N5182A-01

N5182A MXG Vector Signal Generator

“Batch related component issue may result in a non-functioning instrument”.

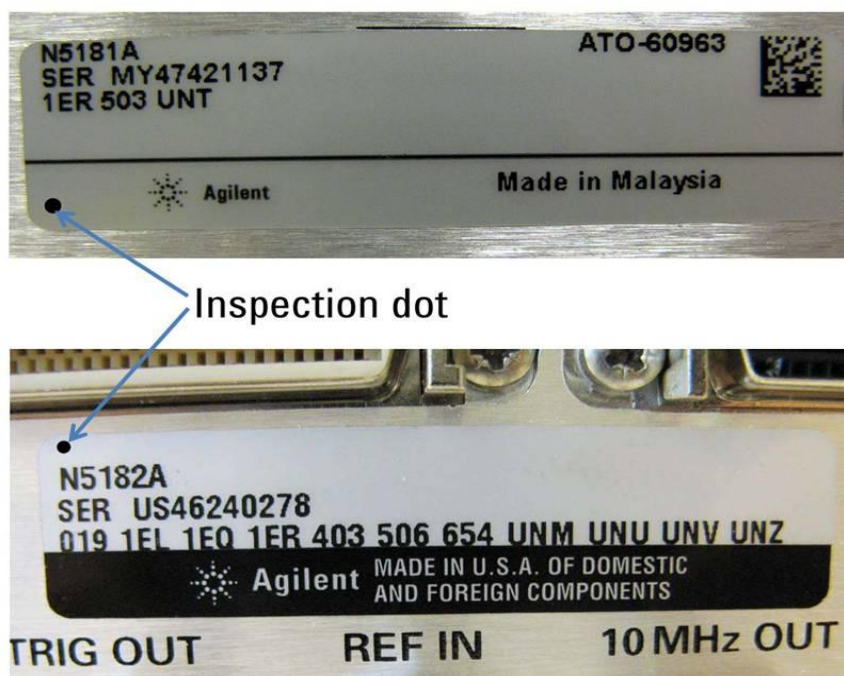
1. Check the rear panel serial tag for a small black inspection dot (see images below). If a black dot is present, similar to what is depicted, the instrument has been checked and no further action is required. If the dot is missing proceed to step 2.
